Access Compliance Report

Public Rights-of-Way

(Curb Ramps)

Intersection ID: 19682	Main Street: FLODDEN_FIELD_CT	Cross Street: YORKDALE_DR	Location: SW
ADA ID: A509DAB1B238	Ramp Type: BlendTrans2	Initial Pass/Fail: Pass	Overall Compliance: No
Codes/Mitigation Info/Possible Solution		Field Measurements/Component Compliance	
Severity Score: 17.75

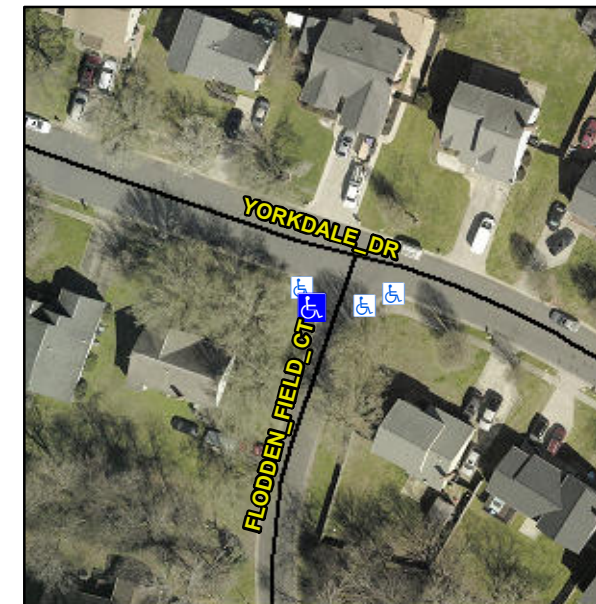
R304.5.3, R305, R302.7.2

Compliance	Description	Data	Compliance	Description	Data
N/A	Ramp Length (in)	92.0	Yes	BlendTrans Slope (%)	4.1
Yes	Ramp Width (in)	56.0	No	BlendTrans XSlope (%)	4.9
N/A	Flare Type LT	None	N/A	Flare Type RT	None
N/A	Flare Slope LT (%)	N/A	N/A	Flare Slope RT (%)	N/A
N/A	Flare Traversable LT?	N/A	N/A	Flare Traversable RT?	N/A
N/A	Landing Length (in)	N/A	No	DWS Provided?	No
N/A	Landing Width (in)	N/A	N/A	DWS Contrast?	No
N/A	Landing Slope (%)	N/A	N/A	DWS Length (in)	N/A
N/A	Landing X Slope (%)	N/A	N/A	DWS Full Width?	No
N/A	Landing Curb? (Y/N)	No	N/A	DWS Offset (in)	N/A
N/A	Shared Landing?	No			
Yes	Gutter Ponding?	No	Yes	Gutter Slope (%)	1.0
No	Gutter Lip Ht (in)	0.5	No	Gutter X Slope (%)	3.2
N/A	Painted X Walk1?	No	N/A	Painted X Walk2?	N/A
	X Walk 1 Direction	To E		X Walk 2 Direction	N/A
	X Walk 1 Width (in)	N/A		X Walk 2 Width (in)	N/A
	X Walk 1 Slope (%)	3.5		X Walk 2 Slope (%)	N/A
	X Walk 1 X Slope (%)	4.8		X Walk 2 X Slope (%)	N/A

N/A	Ramp inside XWalk1?	N/A	N/A	Ramp inside XWalk2?	N/A
	Road Slope (%)	4.8		Clear Space?	Yes
	Road X Slope (%)	3.5	N/A	Clear Space to XWalk (in)	N/A
Yes	Any Obstructions?	No	Yes	Storm Grate/Utility Hazard?	No
	Obstruction Type			Storm Grate/Utility Type	
			N/A		N/A
			Yes	Surface Condition? (G/P)	Good
			N/A	Curb Slope (%)	4.7

Remove & Replace Curb Ramp With Two New Directional Ramps or Equivalent. Remove & Replace Gutter.
